EXHIBIT #13

September 28, 2017

**Subject: Grafton 4 MA, 30 Grafton Common Wireless Telecommunications
Special Permit and Site Plan Review**

Drainage system at the west end of the building.

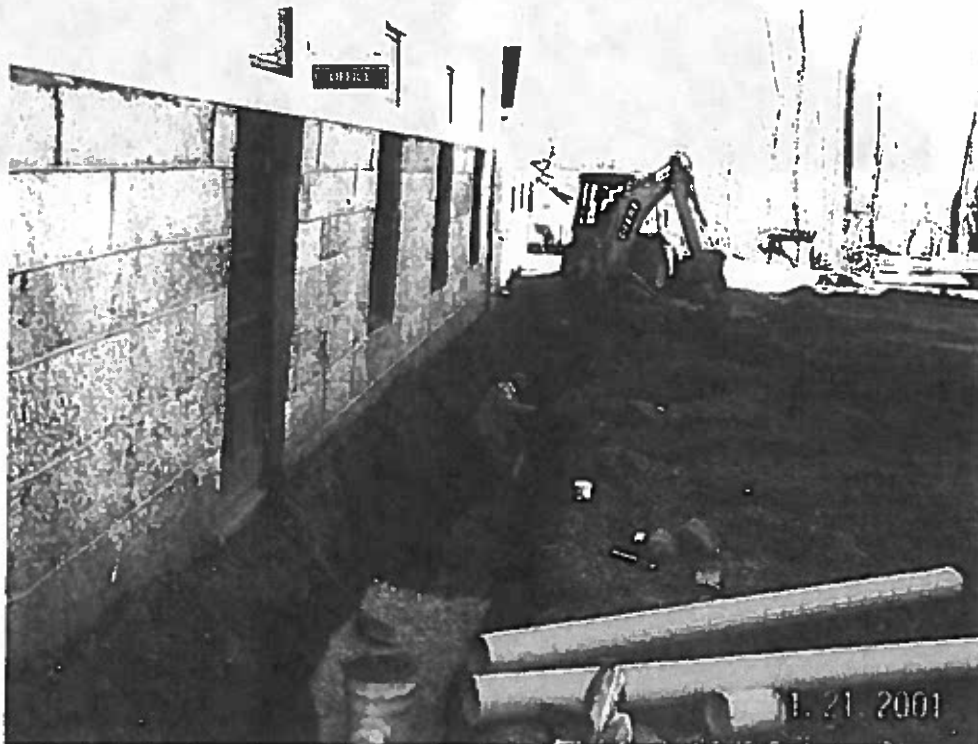
4. Sheets C02 and A01 show in general terms a route between the equipment area and steeple for the electric conduits, telephone conduits and signal cables and list alternative routes. One of the routes is "underground within the yard of the building." Any underground work at the site needs to avoid damage to or negative impacts to an existing drainage system that serves the church building. GEI recognizes that General Note 10 on Sheet C02 addresses existing active utilities. Nevertheless, in 2001 an elaborate system of surface water and groundwater drainage pipes and stone-filled drains to collect roof runoff (these are located along the entire length of the northern and southern sides of the building) was installed, and a pipe for this system passes under the proposed location of the equipment area. Two photographs of the drainage system are presented at the end of this letter. Conduit routing must avoid negative impacts to the drainage system and its functions.

6. Although topographic information was not included on the plans, the equipment pad and fence are proposed in the "low area" between two retaining walls on the western side of the building. This "low area" allows stormwater adjacent to the building to drain away from the building in a westerly direction. The equipment pad and fence are proposed such that they will be adjacent to the southern stone wall and will likely block the flow of stormwater from the area between the equipment pad and the building. The flow of stormwater must not be impeded; the equipment pad may have to be shifted to the north or special provisions made to accommodate stormwater flow around the equipment pad.

Stone-filled drain along the northern side of the building. A similar drain is also present along the southern side of the building.

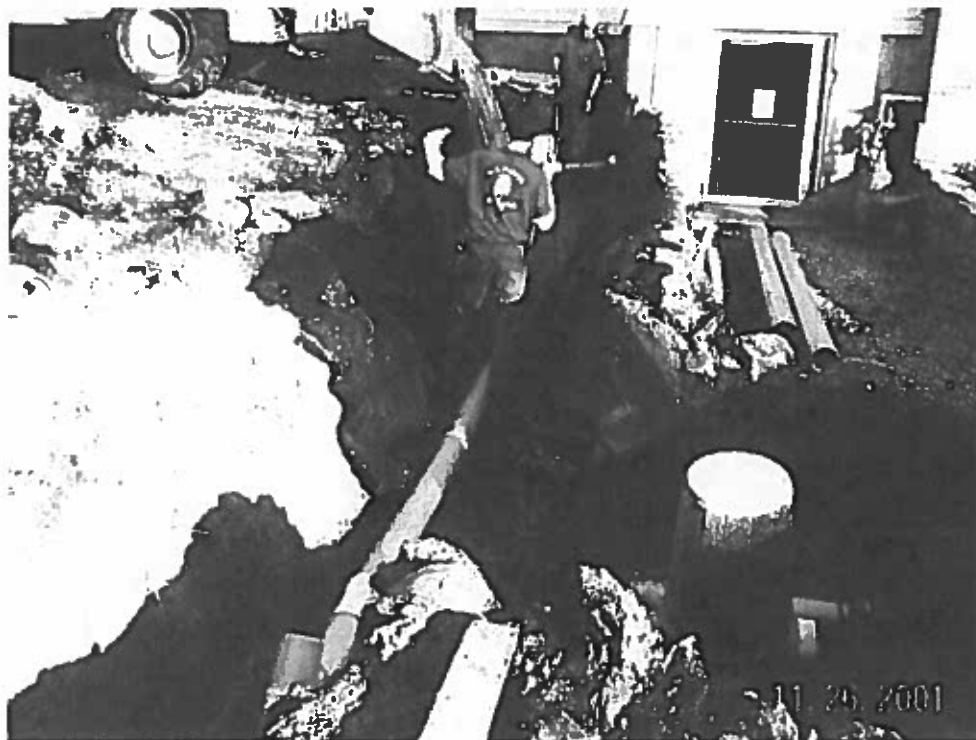
5. Sheets A01 and A02 of the plans identify the ground surface adjacent to the building on the northern and southern sides as being grass. Based upon our visual observations during our site visit and upon our knowledge of the site, these surfaces consist of stone which is part of the site's drainage system. The plans need to be revised to identify the correct ground cover.
